SUNDRY NOTICES AND REPORTS ON WELLS (DO NOT USE THIS FORM FOR PROPOSALS TO DRILL OR TO DEEPEN OR PLUG BACK TO A DIFFERENT RESERVOIR. USE "APPLICATION FOR PERMIT" (FORM C-101) FOR SUCH PROPOSALS.)		WELL API NO. 30-005-28012

Plug And Abandonment Procedure

Cato San Andres #560

Chaves County, NM / API 30-005-28012

Proposed Wellbore Diagram

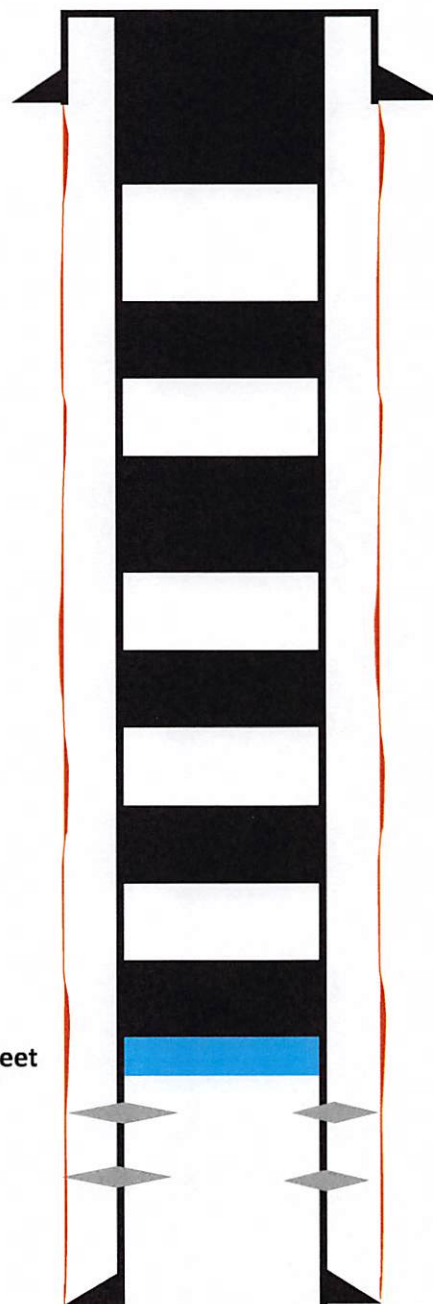
Perf & Sqz all csg shoes.
 Perf & Sqz all plugs w/ no cmt behind pipe.
 Adhere to NMOCD COAs attached.
